McCULLOCH SERVICE BULLETIN

NO. 1590

MODEL MINI MAC. DATE August 19, 1975

SUBJECT 1. Vented Fuel Tank, and Un-Vented Fuel Caps.

Figure 1. Vented Tank.

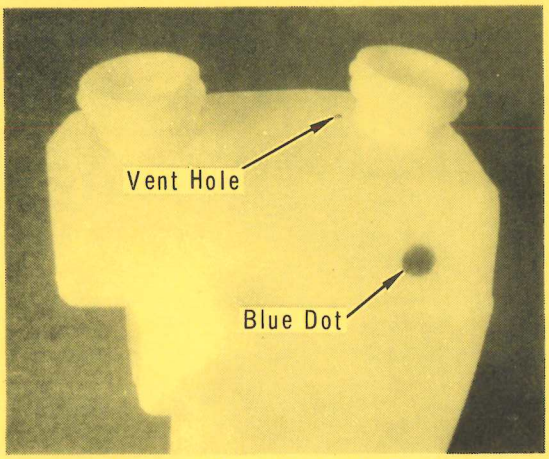
The new vented tank assembly has a vent hole just to one side of the fuel filler neck. For easy identification of this vented tank, the front of the tank has a blue dot near the fuel filler neck. The felt protector is designed to keep the vent from being plugged.

Figure 2. Fuel Tank Caps Compared, Together With Vent Protector.

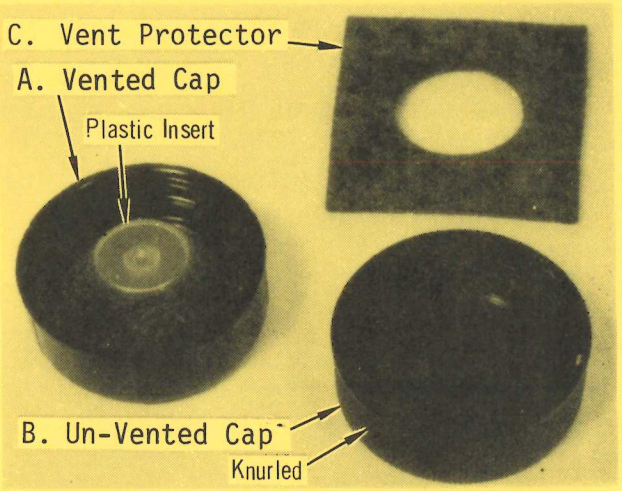
Figure 1 is of the vented fuel and oil tank assembly. Figure 2 shows a comparison of the vented (A) and unvented (B) fuel caps, together with the fuel vent protector (C).

Note that the unvented Fuel Cap, P/N 92183 CAN NOT be used with the earlier unvented fuel and oil tank assembly. Therefore, service replacement vented Fuel Cap, P/N 90922, will be furnished for backfitting the earlier unvented Fuel and Oil Tank Assembly, P/N 83899 or P/N 86441.
